Council Agenda Report

City Council Meeting
02-18-26
Item 1.A.

Subject: Appeal of Planning Commission Resolution No. 24-39 Regarding Coastal Development Permit No. 23-004 (29738 Cuthbert Road, APN 4469-041-011, Owner Malibo LLC, Appellant Charlotte Frieze Jones, for Malibu Park Neighbors Group)

Figure 2a. Site Plan Showing Blueline Stream, 100 feet buffer and encroachment within 100 feet buffer

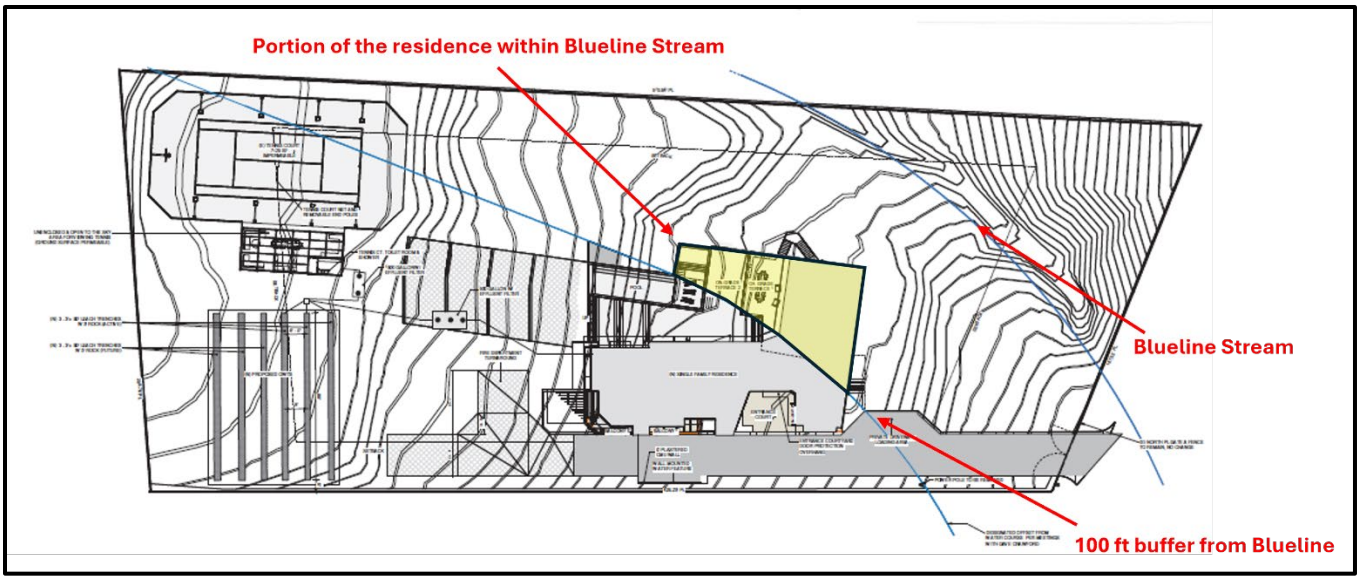
Some portions of the approved residence under PVWF No. 21-034 encroached within 100 feet of the stream (Figure 2a and 2b), as those parts were a like for like replacement. The subject application is for the addition of 4,620 square feet to the approved residence. Under this application, only the new portions of the residence are being reviewed.
